Subject: PSB E264: PACCAR MX-13 EPA2017 Cylinder Head Bolt Tightening
EXPIRATION DATE: 02/01/2022

Technical Information Bulletin

E264

PACCAR MX-13 EPA17 Cylinder Head Bolt Tightening

Figure 1 Head bolt locations

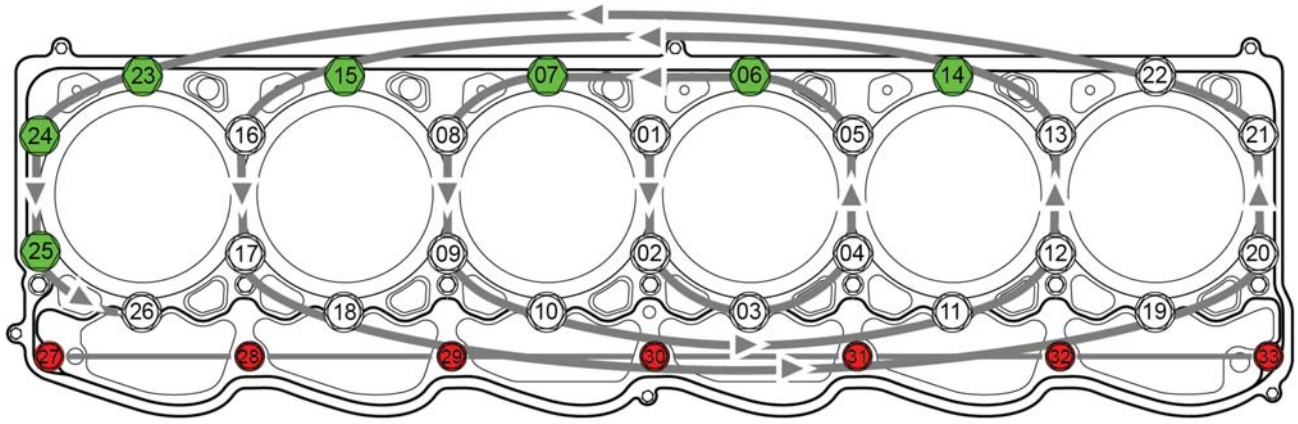
2. Confirm head bolt numbers 06, 07, 14, 15, 23, 24, 25—shown in **green** in Figure 1—**DO NOT** have a clean and visible index mark. If they have a clean index mark, **you MUST** confirm that this repair was not recently performed. Bolts 23 and 15 are easiest to see.

5. Turn head bolts 1-26 90°.
 - DO NOT RETORQUE BOLTS 27-33 shown in Figure 1 in red.
 - Use the torque adapter tool (p/n 2203481PE) on limited access bolts (head bolt numbers 06, 07, 14, 15, 23, 24, 25—indicated by green highlight in the image below). This tool allows for access under the EGR cooler.

Figure 1 Head bolt locations

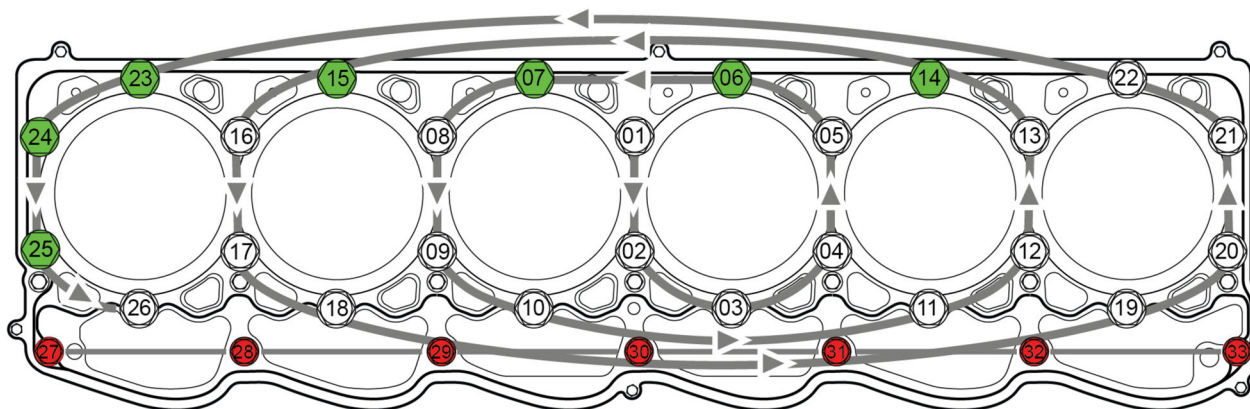
1. Confirm head bolt numbers 06, 07, 14, 15, 23, 24, 25—shown in green in Figure 1—**DO NOT** have a clean and visible index mark. If they have a clean index mark, you **MUST** confirm that this repair was not recently performed. Bolts 23 and 15 are easiest to see.
2. Remove the engine brake rocker assemblies per RMI job called "*replace 2 (two) rocker arm group, engine brake (Basic assembly)*".
3. Index (add witness marks) to head bolts 1-26 to indicate the starting and ending points for reference as shown in Figure 2 in green.
4. Turn head bolts 1-26 90°.
 - DO NOT RETORQUE BOLTS 27-33 shown in Figure 1 in red.
 - Use the torque adapter tool (p/n 2203481PE) on limited access bolts (head bolt numbers 06, 07, 14, 15, 23, 24, 25—indicated by green highlight in the image below). This tool allows for access under the EGR cooler.
